New Pages of the
Technical Specifications

3.6.1.9 Feedwater Leakage Control System (FWLCS)

Technical Specification Bases Changes

Technical Bases for the FWLCS Mode of RHR

Figure 1

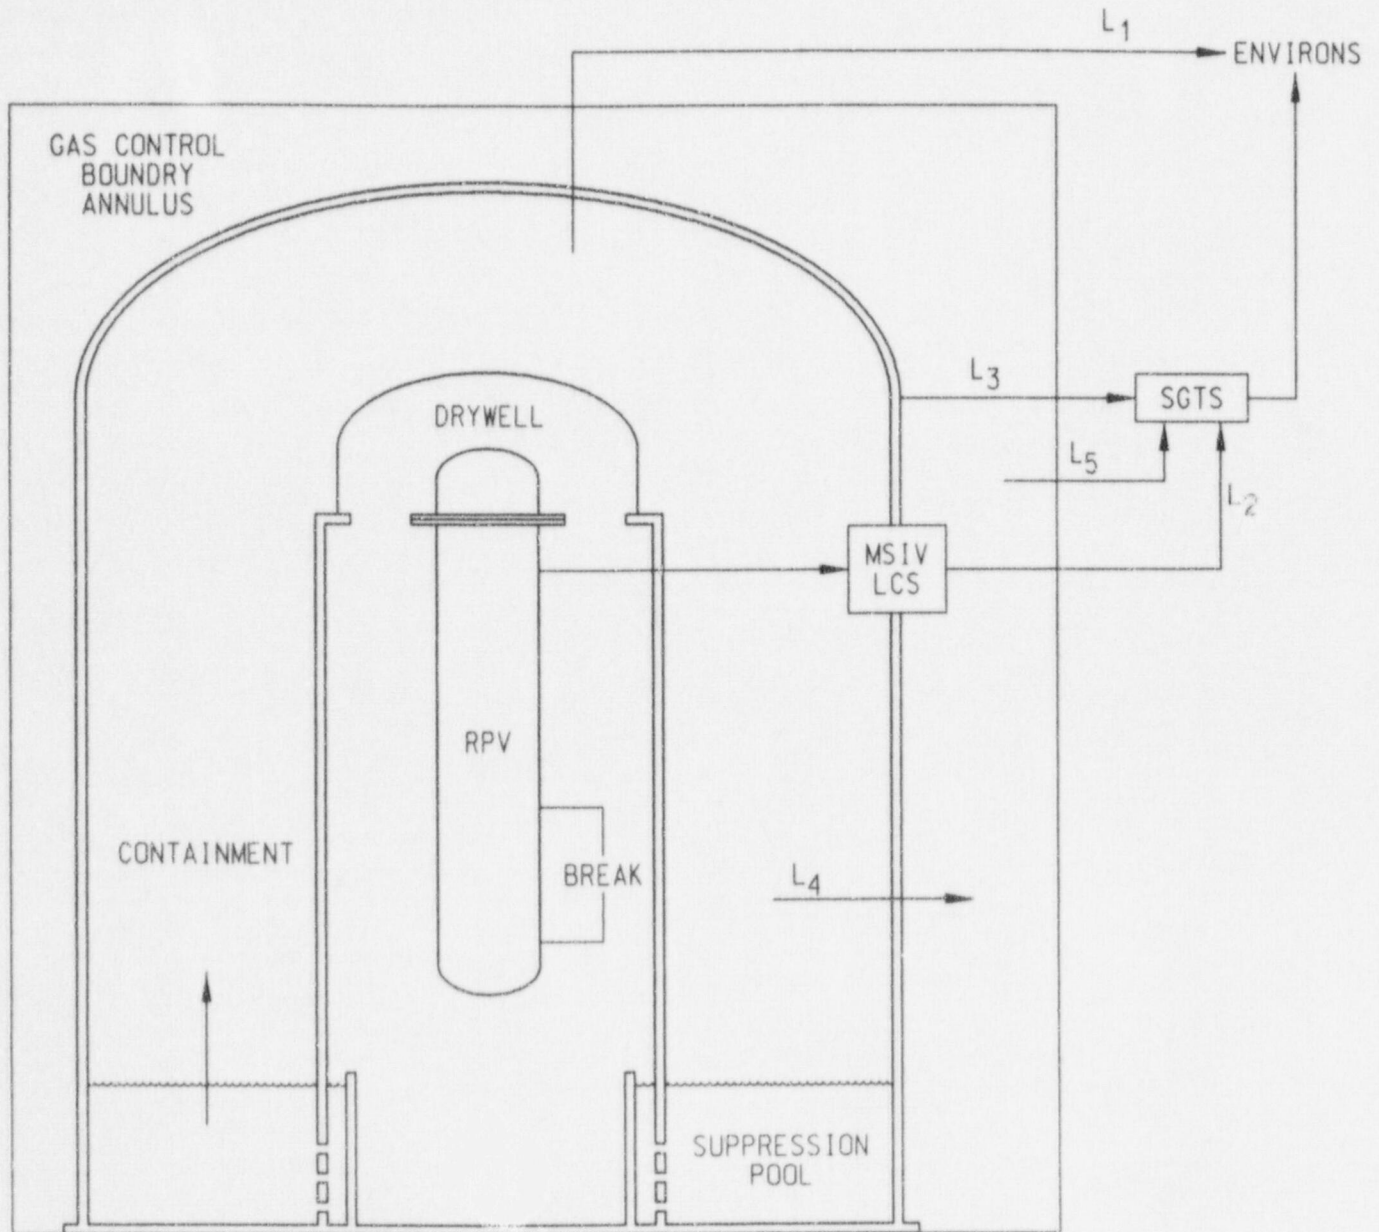
¹ Figure 1 corresponds to Figure 15.6.5-1 in the CPS USAR.

Leakage paths L_4 and L_5 are associated with the realistic analysis for assessment of the dose consequences for the DBA LOCA. As such, they are not relevant to the design basis analysis addressed in USAR Section 15.6.5.5.1 nor to the analysis addressed in this attachment. These leakage paths appear in the USAR Figure 15.6.5-1, however, and are included in Figure 1 for consistency.

Figure 2

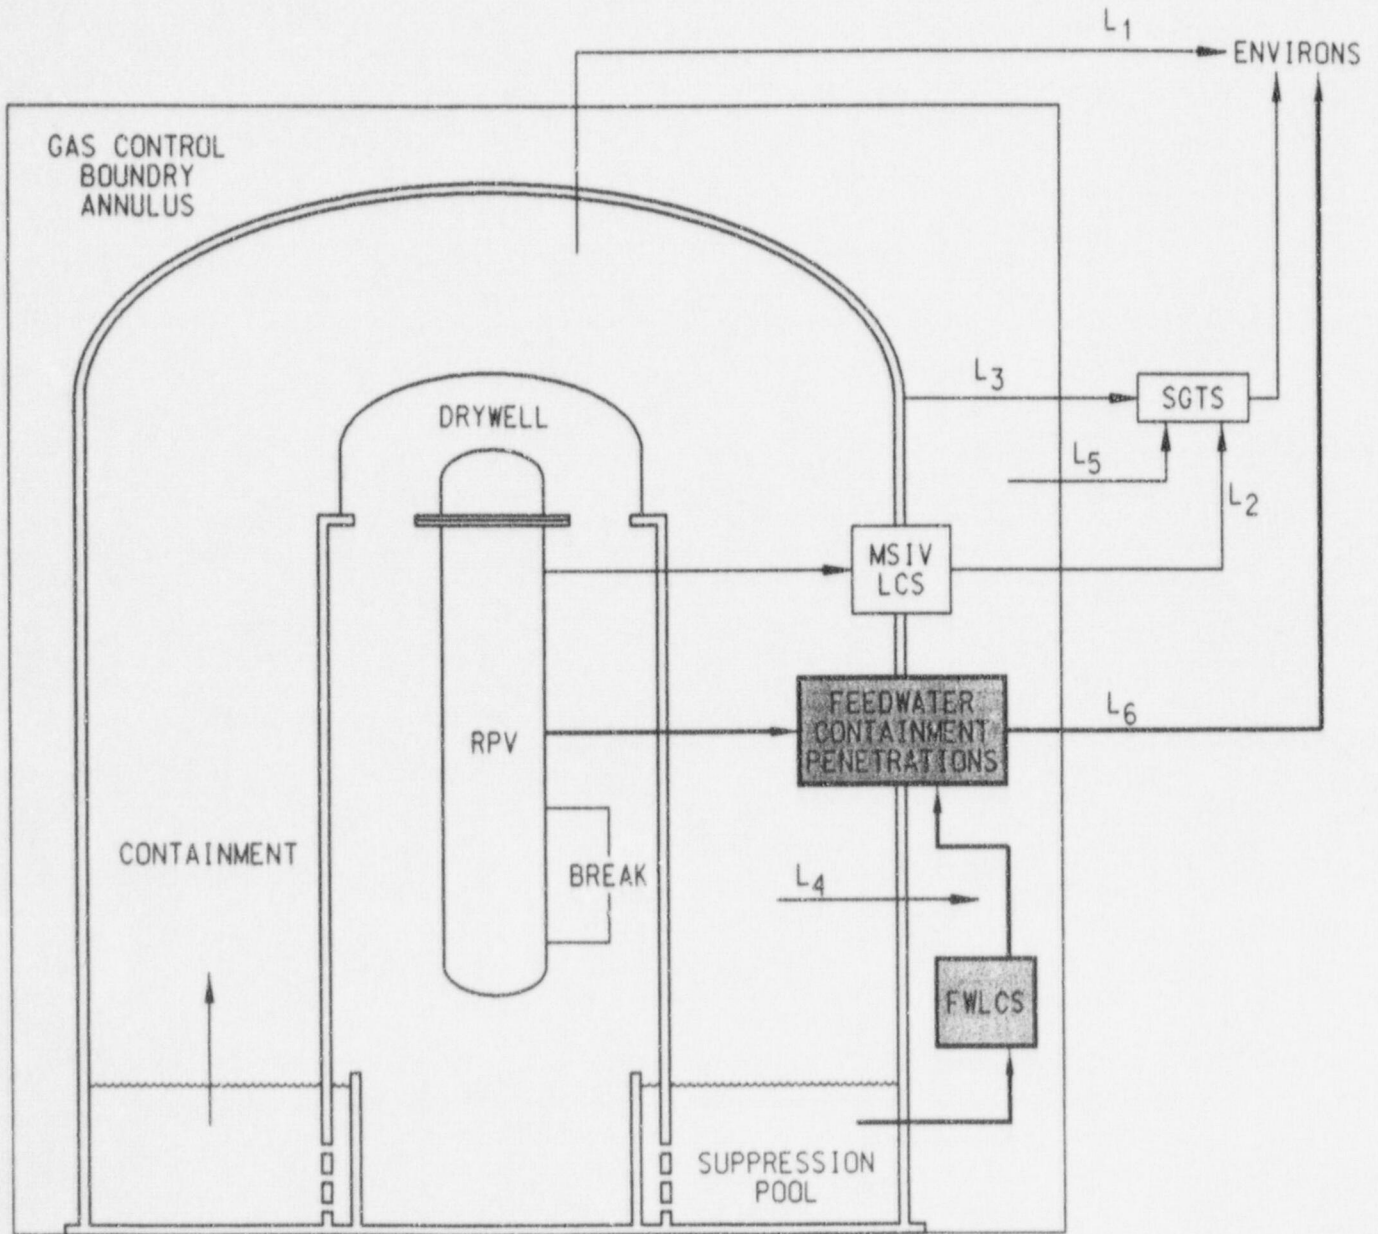
Introduction of the FWLCS and associated changes to the leak test requirements for the feedwater containment penetrations requires consideration of an additional leak path dedicated to the feedwater containment penetrations, which has two components, as depicted in Figure 2 (page 12 of this attachment). This pathway (depicted as L_6 in the figure) is also a secondary containment bypass leakage path, but is evaluated as a separate and distinct pathway to the environs that is in addition to the above-noted pathways. The leak rate assumed for this pathway corresponds to the leakage assumed to occur through the feedwater containment isolation valves has two components. For the purposes of analysis, leakage through this pathway is conservatively assumed to be entirely containment atmospheric leakage from the time immediately following the DBA LOCA until the feedwater piping is completely filled with water by the FWLCS. This time period is assumed to be one hour. Water leakage (post-LOCA suppression pool water) is also assumed to occur via this pathway, and is assumed to occur for the entire 30-day post-LOCA period. The limits assumed for these leakages, which were important inputs to the dose analysis performed, are further discussed below.
